April 7, 2025

Barbara Lynch  
Chair, Salford Township Board of Supervisors  
139 Ridge Road P.O. Box 54  
Tylersport, PA 18971

**Re: Evaluation of 2023 V.F. Britton Group Groundwater Modeling Report and  
September 2024 NPDES Permit Amendment for the Naceville Materials Quarry  
West, Rockhill Township, Bucks County, PA**

**HYDROGEOLOGIC ZONES**

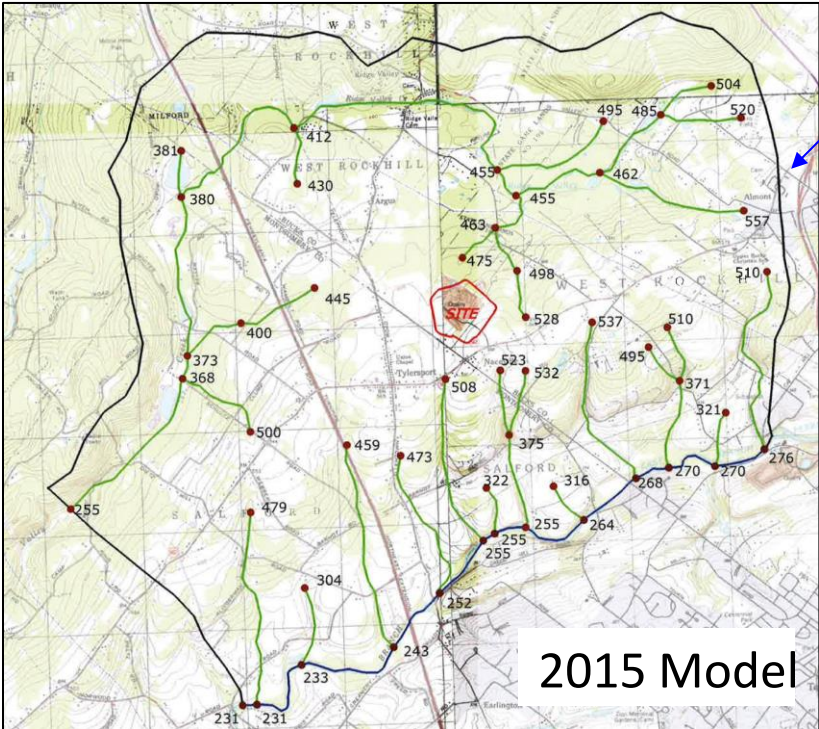
**Comment 5** – The 2023 Britton Group Model’s construction does not capture the complex geologic controls on groundwater flow as it relates to the stated model objectives. Specifically, the complex bedrock hydrogeologic conditions at, and in the vicinity of, the site are represented in the 2023 Britton Group Model as an Equivalent Porous Medium (EPM). As shown in **Figure 1**, the model does not properly incorporate the dipping bedrock strata (including the Brunswick and Lockatong Formations), nor does it take into account bedding plane partings associated with these formations (where many private water supply wells likely draw water from). Further, since the model is set up using a rectilinear grid, the area of grid refinement does not take into account important site characteristics, including the orientation of subsurface geology, or wells of interest located along Ridge Road.

Modified from 2023 Britton Group Modeling Report, Figure 4,  
2015 Britton Group Modeling Report, Figure 3

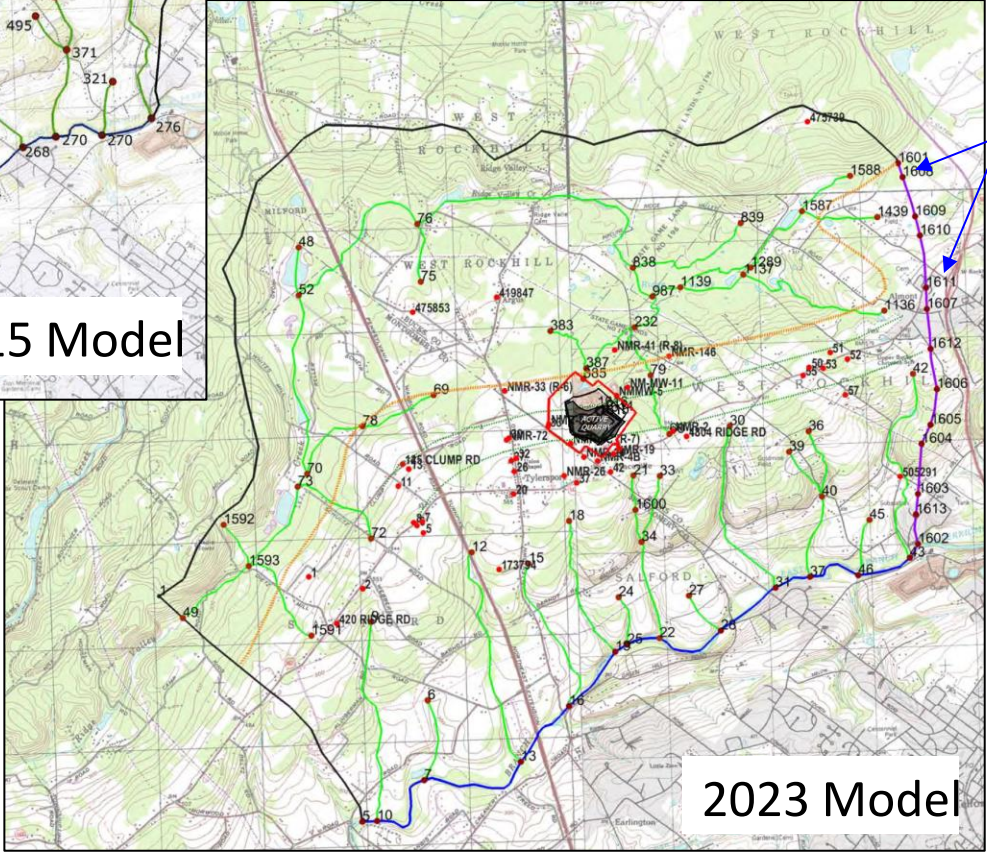
**Comment 6** – Comparison of the 2023 Britton Group Model with the 2015 Britton Group Model indicates that the eastern model boundary was modified from a no-flow boundary in the 2015 Britton Group Model to a specified head boundary “...to allow water to freely move past this boundary at specified head elevations since no natural or hydraulic groundwater divides exist in this

*direction.*” (2023 Britton Group Modeling Report, Section 2.2, page 10) (**Figure 2**). This is incorrect. In fact, the original assignment of the eastern boundary as a no-flow boundary in the 2015 Britton Group Model is more appropriate, as this boundary is located along a natural groundwater divide. Instead, use of a specified head boundary would likely have been more appropriate along the southwestern model boundary, where no natural groundwater divide exists. Although QHS consulting has not had the opportunity to review and analyze modeling files for the 2015 and 2023 Britton Group Models to examine the effects associated with the assignment of a specified head along the eastern model boundary, the use of this boundary condition will maintain heads at the assigned elevations along this boundary. Coupled with the use of a no-flow boundary to the southwest, boundary assignments may artificially reduce the amount of drawdown in the model that is calculated due to quarry operations.

2015 Model

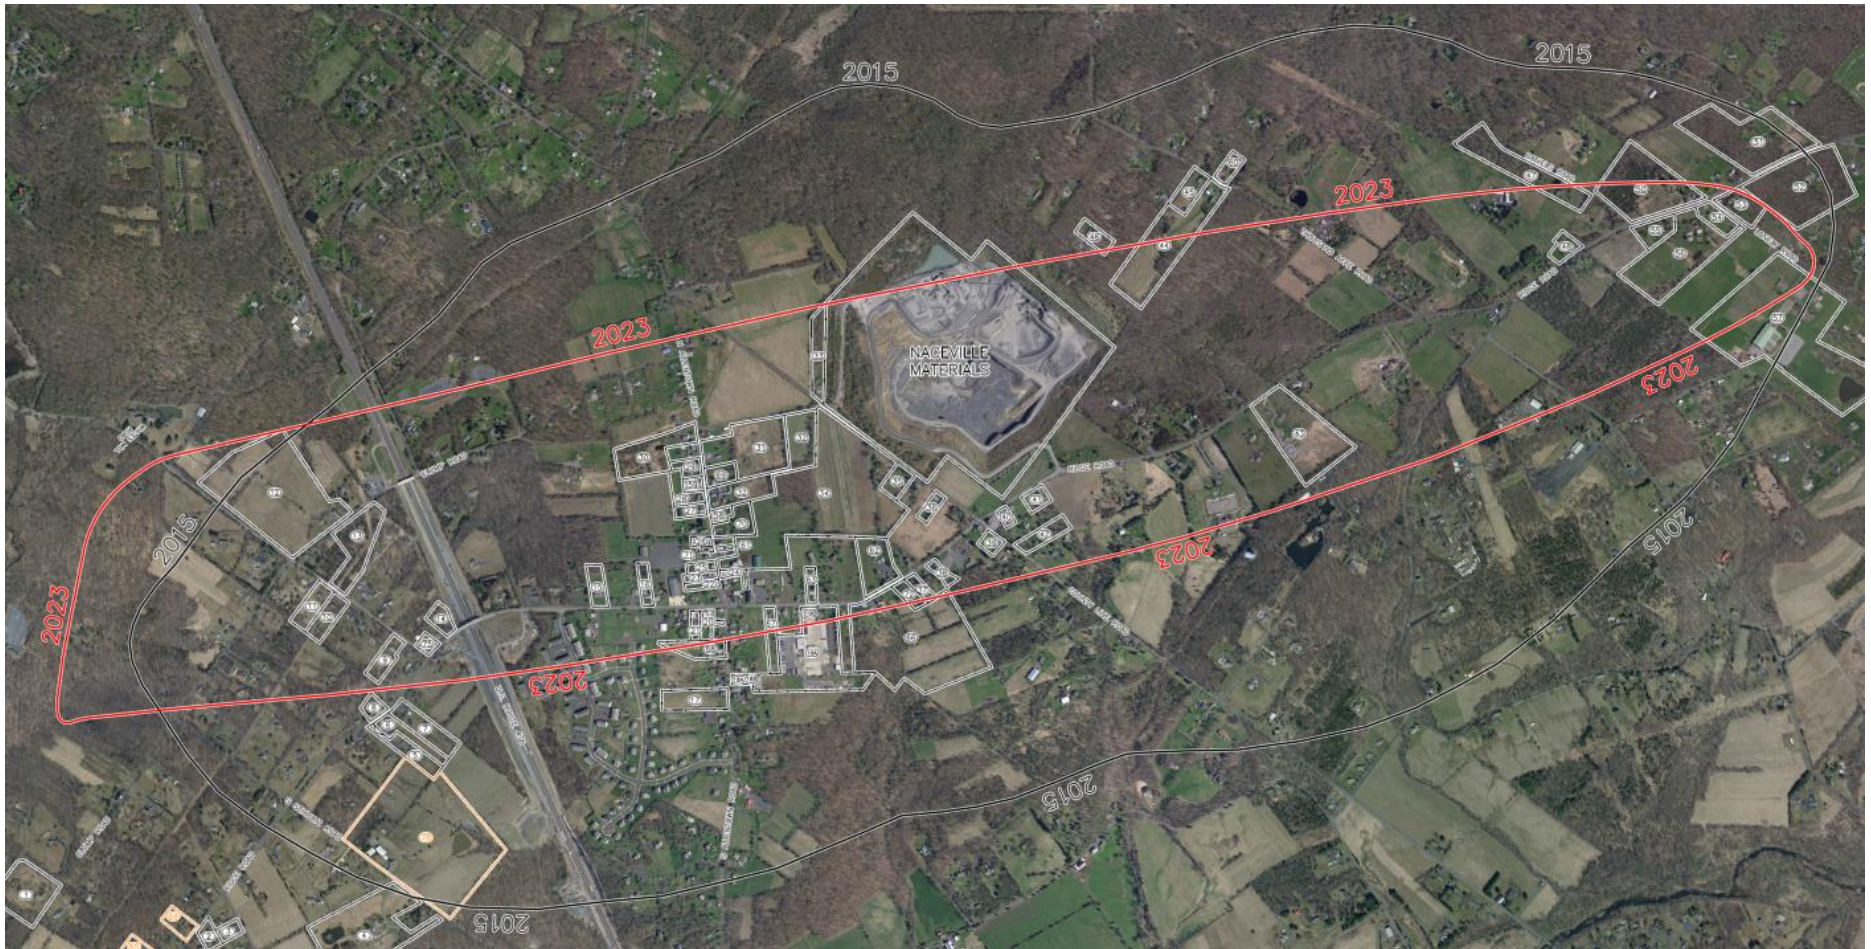
**Comment 10** – In addition to use of higher hydraulic conductivity values in the 2023 Britton Group Model, horizontal anisotropy values were also modified in the 2023 model compared to the 2015 model. As noted in the 2023 Britton Group Modeling Report, site-specific aquifer pump tests performed by H&K indicated a horizontal anisotropy ratio ( $K_y/K_x$ ) of 0.3. This field measured anisotropy value was utilized in 2015 Britton Group model. Although the 2023 Britton Group Modeling Report states that “*This ratio was assigned to the Brunswick Group and the Locketong Formation material within the model during the calibration process*” (pg. 12), Figure 7 of the 2023 Britton Group Modeling Report (which includes a table with hydraulic conductivity and anisotropy values utilized in the calibrated groundwater flow model) indicates that horizontal anisotropy values utilized in the 2023 Britton Group Model were 0.5 for the thin uppermost layers (model zones 102, 103, 104), but was adjusted to 0.01 for the other argillite model zones. Justification for significantly lowering the anisotropy ratio for these model layers was not provided, and as noted above, is not consistent with the field measured horizontal anisotropy value of 0.3. Importantly, the use of these significantly lower horizontal anisotropy values likely results in the reduction in quarry drawdown in the Y direction (i.e., to the north-northwest and to the south-southeast) when compared to the 2015 model, which is evident when comparing the Zones of Influence (ZOIs) generated by the 2015 and 2023 Britton Group Models (**Figure 3**).

### Computed vs. Observed Values Head

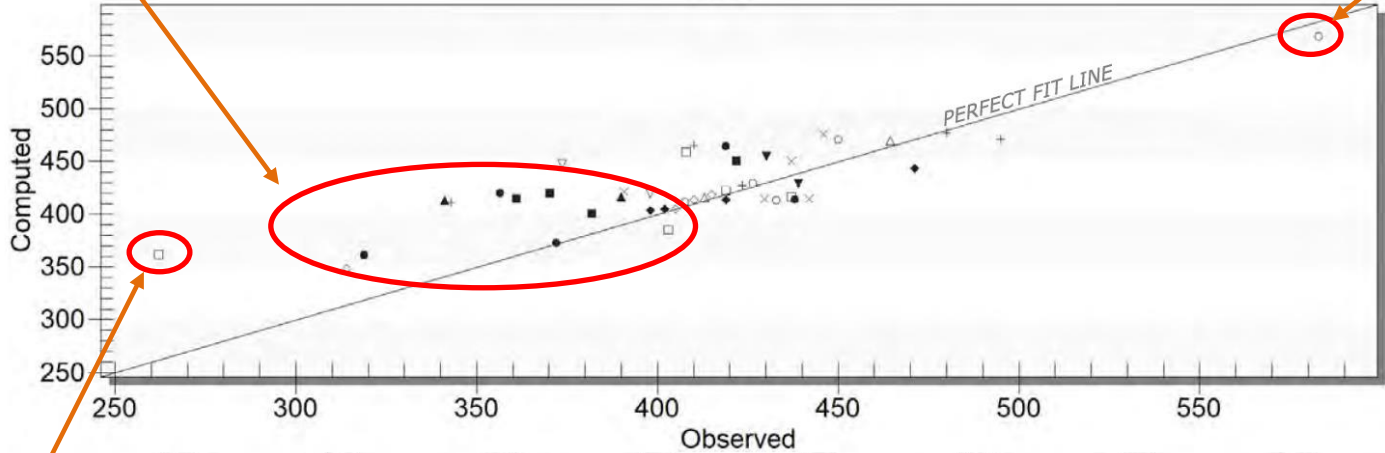
where  $h_i^{sim}$  and  $h_i^{obs}$  are the simulated and observed heads for well  $i$ , respectively, and  $h_{max}^{obs}$  and  $h_{min}^{obs}$  are the maximum and minimum observed heads, respectively. Because the simulated head for 475739 is near the perfect-fit calibration line (see **Figure 4**), it adds minimally to the residuals (the numerator of Eq. 1). However, because its observed head (583 ft) is 103 ft greater than the next highest head (well 419847, head = 480 ft), the denominator increases markedly, making the NRMSE much smaller, resulting in a calibration fit that appears better simply by the inclusion of well 475739. For example, if well 475739 is removed from the calibration dataset, the calibration is much poorer, with a recalculated NRMSE from the remaining 44 wells of 15.14%. As noted previously, well 505291 also influences the NRMSE, because it is the lowest observed head. When

**Comment 13** – A review of the calibration results for the 2023 Britton Group Model indicates that observed head observation points at lower elevations are generally much lower than computed modeled heads (see **Figure 4**). The locations of these wells are primarily located in proximity to west of the Quarry (**Figure 5**). Further, evaluation of observed and modeled heads for several wells in this area indicates that the model overpredicts heads by more than 70 feet in some instances (see **Table 3** below).
